Access Compliance Report
Public Rights-of-Way
(Curb Ramps)

Main Street: PALM_DR | **Cross Street: CEDARLAWN_DR** | **Location: NW**

ADA ID: RPAT210917102223 | **Ramp Type:Type 1 - Perpendicular Diagonal Initial Pass/Fail: Pass** | **Overall Compliance: No** | **Severity Score: 4**

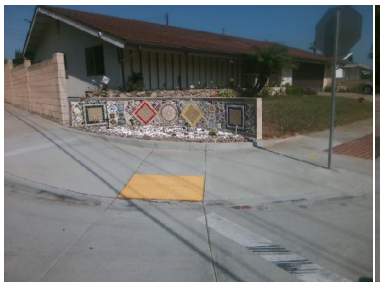
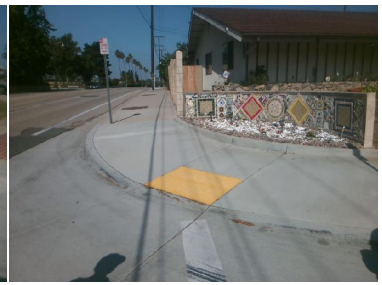
R304.2.2, R304.2.1, R304.5.3, STD 1115

Remove & Replace Curb Ramp With Two New Directional Ramps or Equivalent. Remove & Replace Gutter.
